# Service Bulletin

Date: **08 May 2020**

Subject: **New EAS cable layout**

Product: **Brutale 1000 Serie Oro - RR See attached VIN list**

**Identification of the cable's layout:**

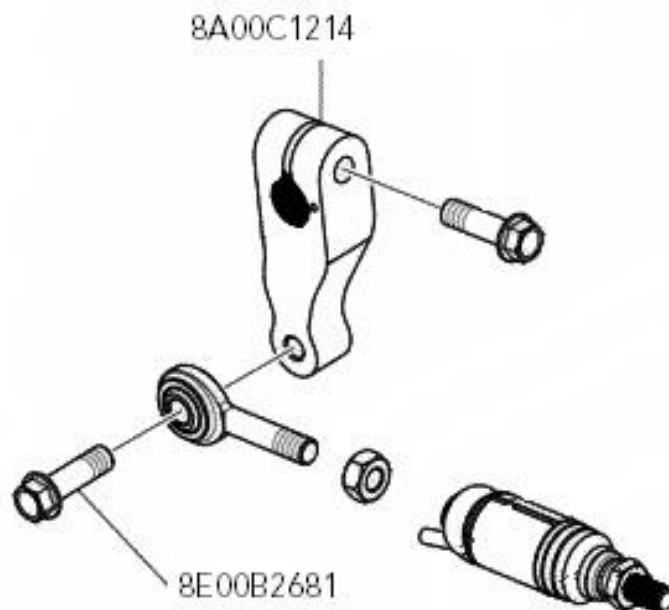
As part of the process of continuous improvement of the quality of our products, we inform you of the new positioning relative to the cable of the EAS cell, having found that on some vehicles the cable is in an incorrect position which could cause damage to the wiring itself and consequent malfunction of the electronic shift assistance system.

1. Remove the L40 rubber clamp on the 8A00C1214 gearbox connecting rod; the same must not be used in the new development of the cable passage.
2. Remove the M6X20 fixing screw cod. 8E00B2681 (Serie Oro- RR) on front side of the EAS rod:
